Date 9-25-07**PLAN REVIEW REVISION SUBMITTAL**

Project name RESIDENCES @ TROLLEY PARK

REVISION TO SWITCHBOARD SERIES PANEL RATING**----- THIS SPACE FOR OFFICE USE ONLY -----****Reviews****Review time**

We are in receipt of the plan review comments by the City of Aurora Building Department. Below are the comment numbers followed by our responses. Please forward this information to the appropriate parties for review.

1 GARAGE LEVEL ELECTRICAL PLAN

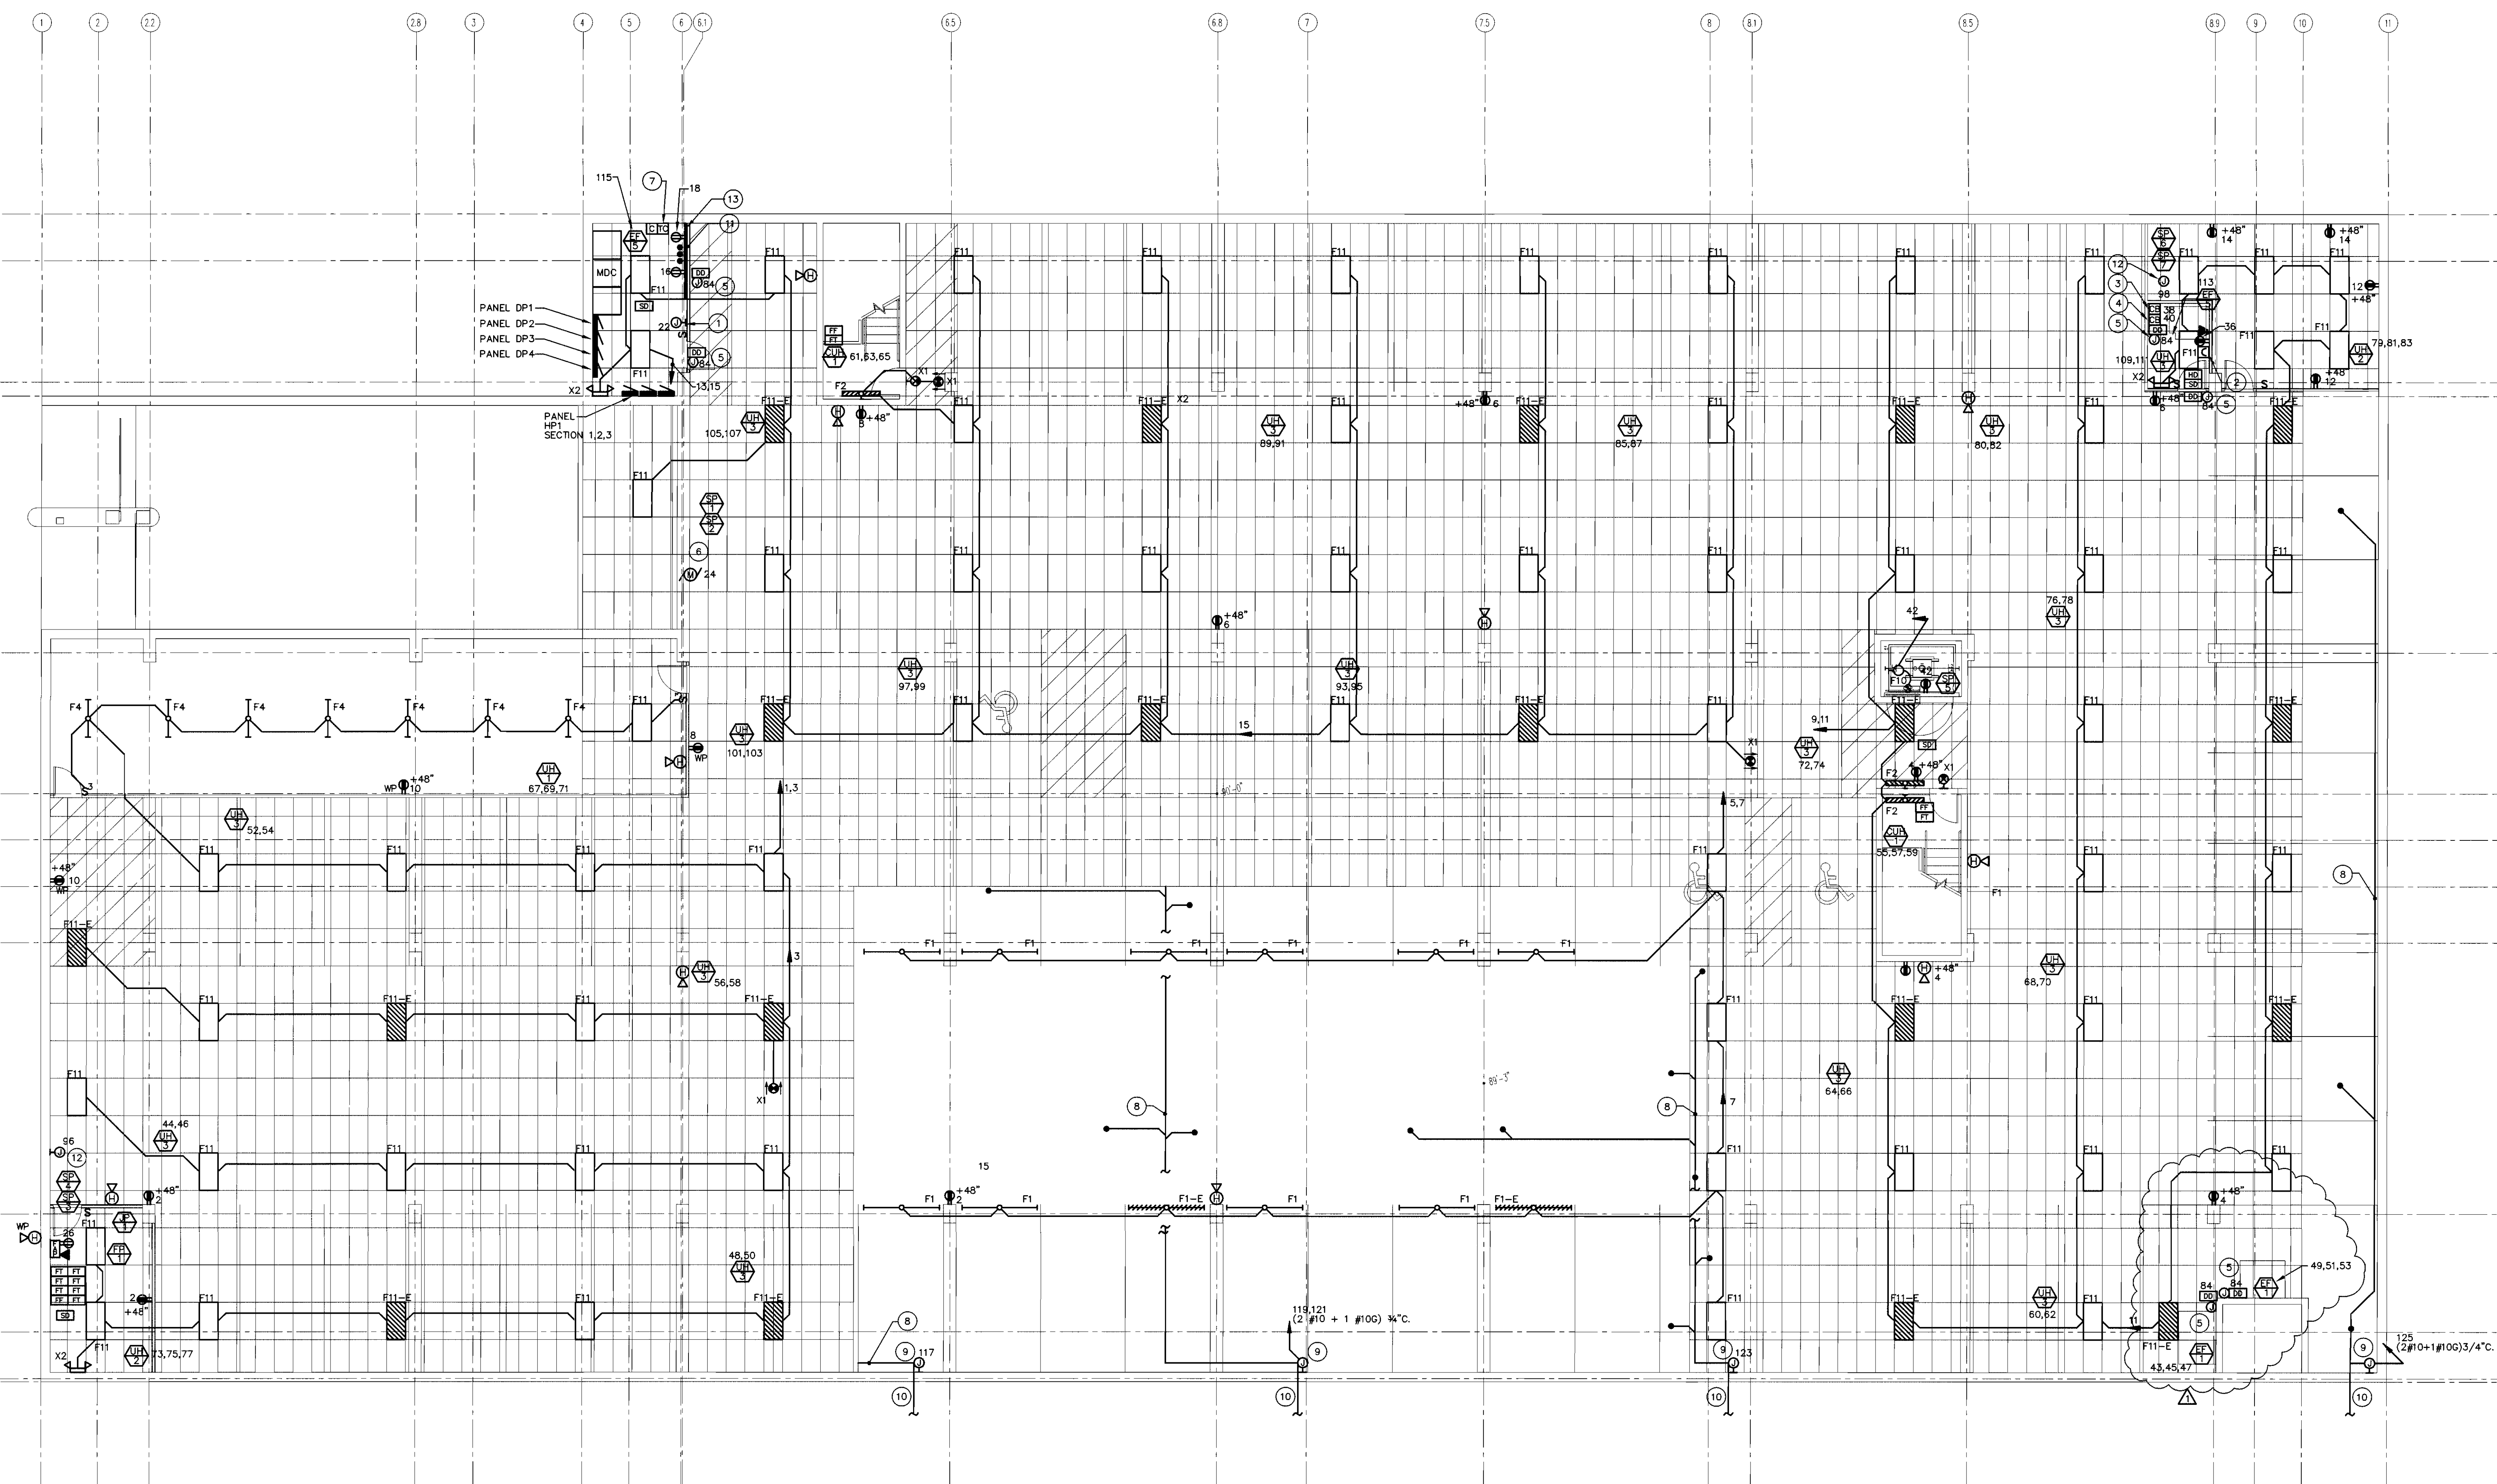
Sheet E2.1 Relocate exhaust fan EF-1 and fire smoke dampers to relocated area well. See revised drawing E2.1.
